**2.0 Geology and Topography, Comments and Responses**

### **2.3 Comments on the DEIS and Responses to Comments**

### PHASE III

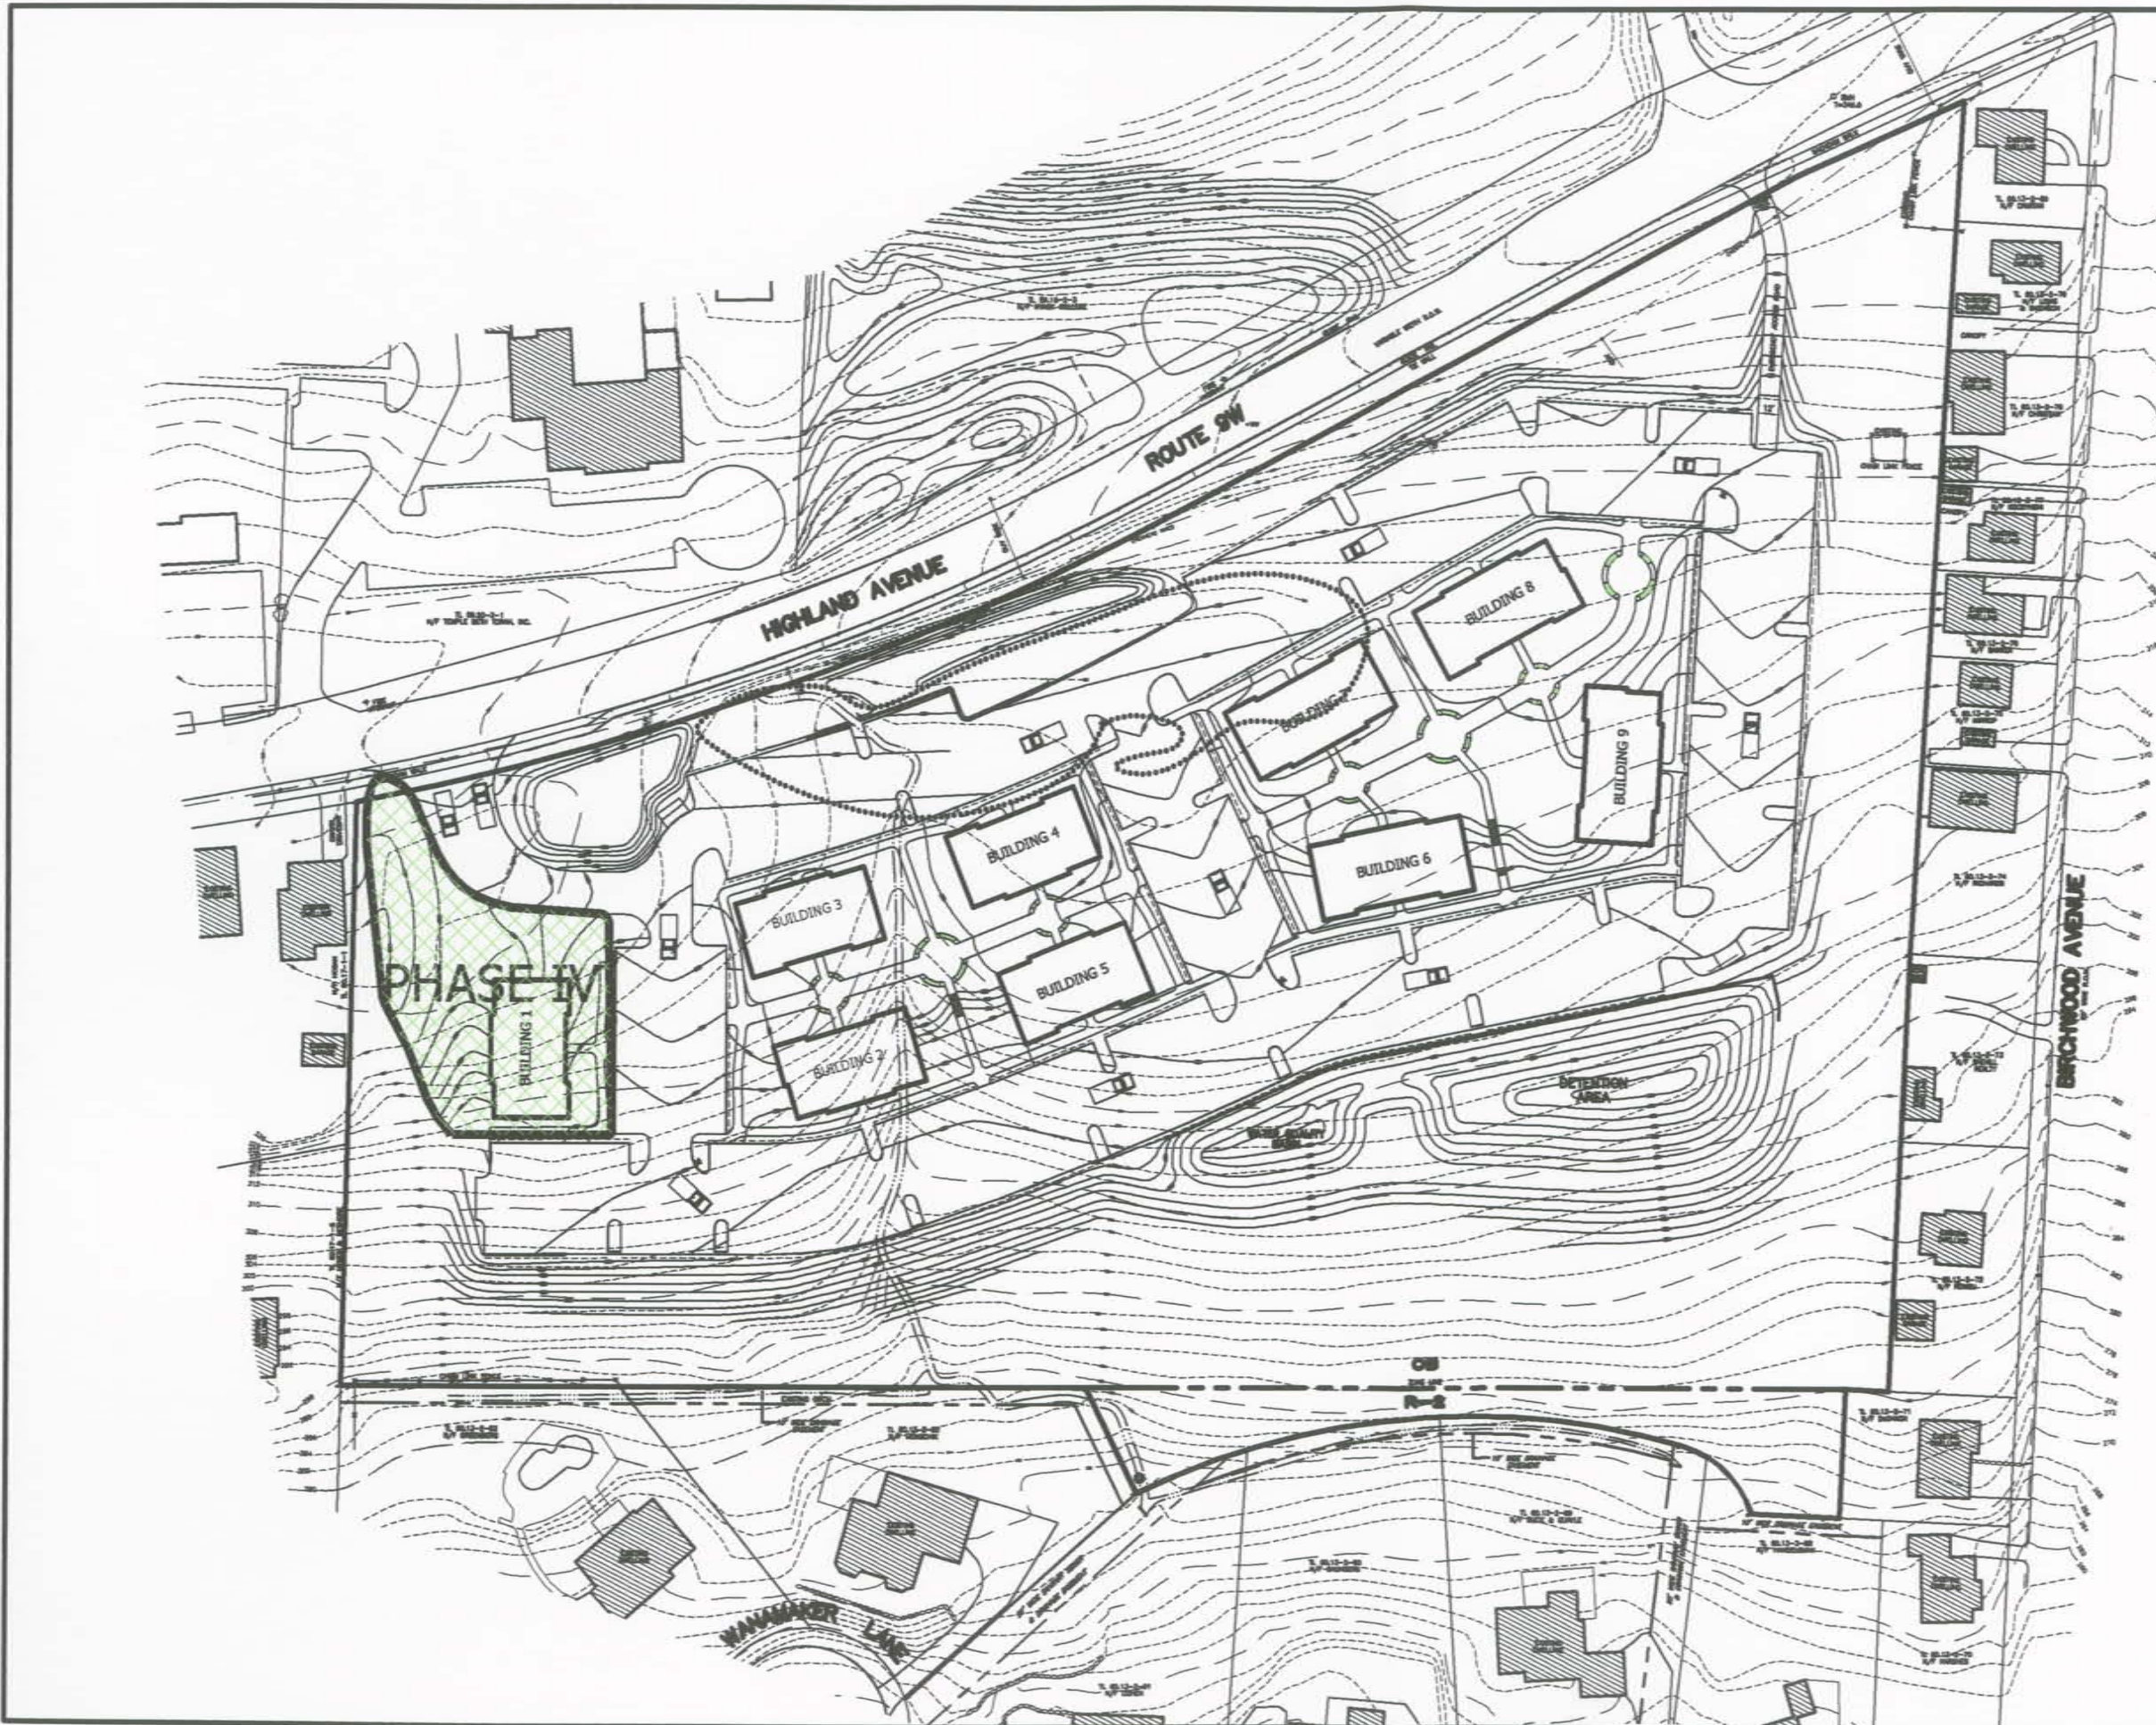
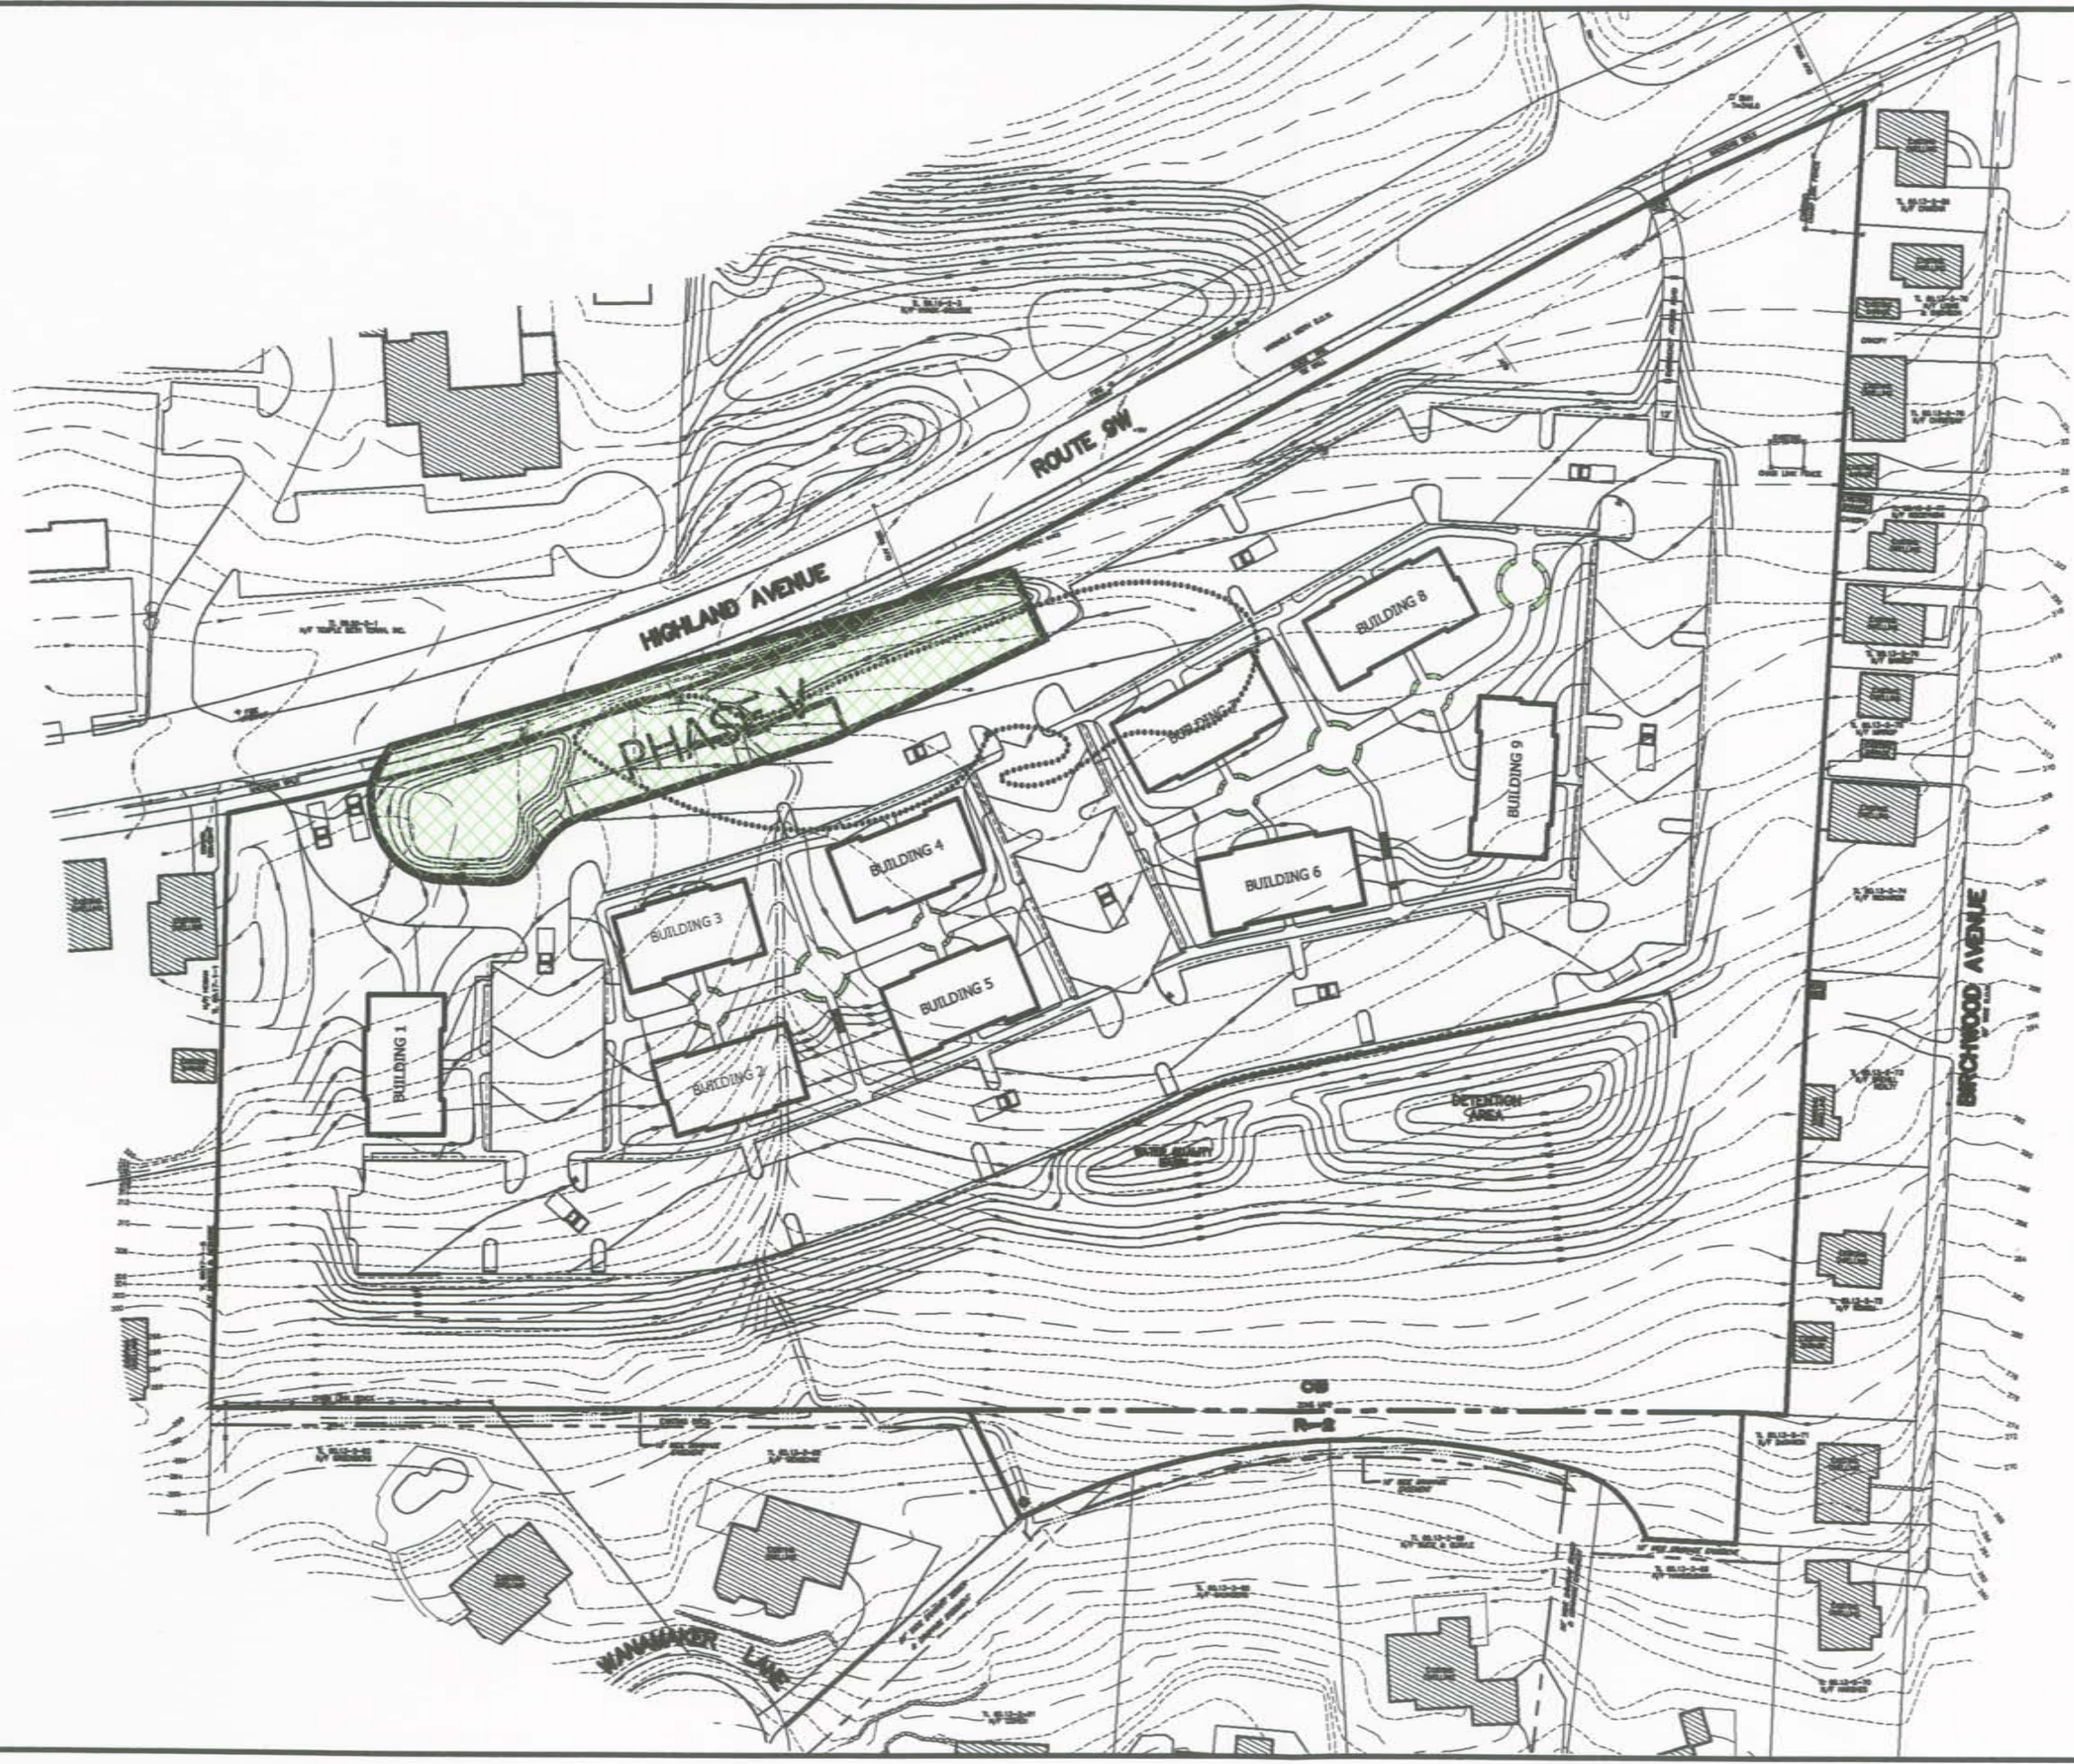
**Comment 2-9 (Letter #22, Robert Geneslaw, Robert Geneslaw Co., 2/1/05):** Section 3.1.2 Potential Impacts [of Land Resources]. Please provide a graphic representation of how 20-yard trucks would enter and exit the site, and where waiting areas would be for the truck for loading.

***Response 2-9: Commercial Nine Building Plan*** - *The project engineer prepared figures titled "Site Phasing Plan and Truck Routing Diagram" which shows the requested information. These figures are provided at the end of this section.*

***Residential Subdivision Plan*** - *For this alternative the site phasing plan will provide the requested information. Due to the significant reduction in truck traffic associated with the residential alternative, the locating of truck staging areas is not presumed to be a problem.*
